Technical change to RD and RI interfaces

PCN-number: 20211122

Date of publishing: 11-22-2021

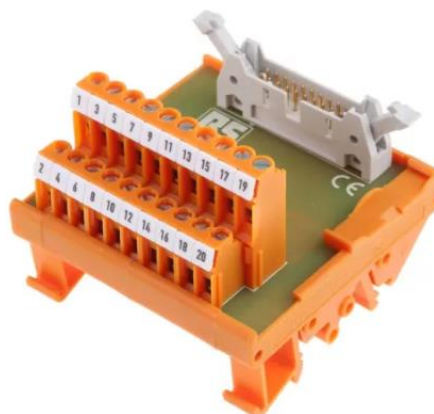
Based on continuous improvement the LP and LP1N (apparently LP2N) connectors will be replaced by LL2N connectors with KSW strip markers.

Obsolescence of LP and LP1N connector range.
